MANUAL HARD COPY DISTRIBUTION
DOCUMENT TRANSMITTAL 2004-48843

TRM2 - TECHNICAL REQUIREMENTS MANUAL UNIT 2

SUSQUEHANNA STEAM ELECTRIC STATION
LIST OF EFFECTIVE SECTIONS (TECHNICAL REQUIREMENTS MANUAL)

Rev. No.	Affected Sections	Description/Purpose of Revision
0	ALL	Issuance of this COLR is in support of Unit 2 Cycle 12 operation.
1	5.0 6.0 8.0	<p>This revision adds a text box to all appropriate plots. This text box indicates that for all bypass operable cases, four bypass valves are assumed operable. For the bypass inoperable cases, the text box indicates that two or more bypass valves are assumed inoperable.</p> <p>This revision was generated in response to Facility Operating License Amendment 185 which altered SR 3.7.6.1.</p> <p>This revision is administrative in nature and no underlying calculations or plotted data were altered.</p>
2	TOC 1.0 9.0 10.0	<p>This revision adds the Power / Flow map to the COLR. Section 1.0 was revised to include the stability regions as part of the COLR. The Power / Flow map was added as Section 9.0. The Reference section was renumbered as Section 10.0 and a stability reference added.</p> <p>This revision is administrative in nature since the Power

MCPR OPERATING LIMIT VERSUS CORE POWER
EOC-RPT AND MAIN TURBINE BYPASS OPERABLE
TWO LOOP OPERATION (BOC TO EOC)
FIGURE 5.2-2

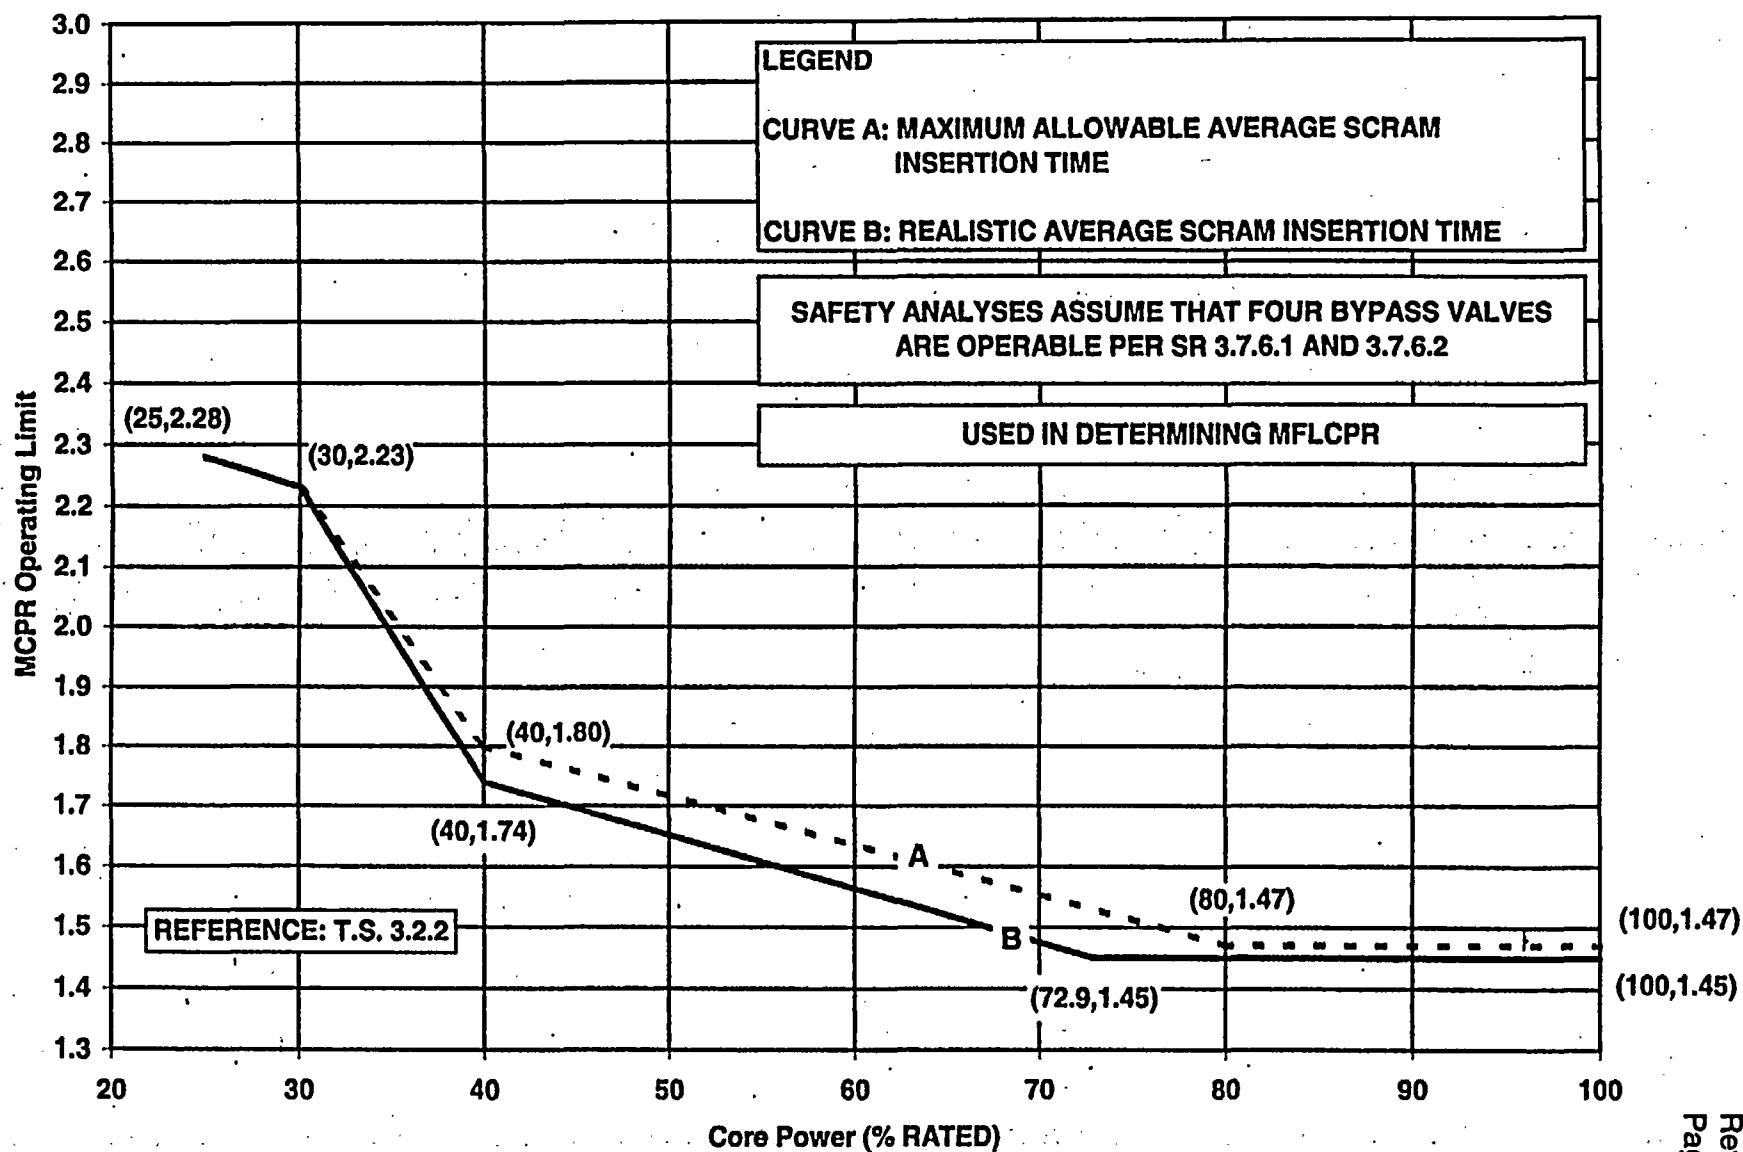
3	5.0 8.0 10.0	<p>The figures within Section 5.0 and Section 8.0 are revised to incorporate the 0.02 MCPR Safety Limit reduction approved by Amendment No. 191.</p> <p>Figure 5.2-2 is revised to correct the Operating Limit error documented by CR 606127.</p>
4	TOC 1.0 2.0 9.0 10.0 11.0	<p>This revision changes the Power / Flow map and adds setpoints for the OPRM system. The change to the Power / Flow map provides direction when the OPRM system is OPERABLE and inoperable. The setpoints for the OPRM system are set to reliably detect and suppress anticipated stability related power oscillations while providing a high degree of confidence that the MCPR safety limit is not violated.</p>
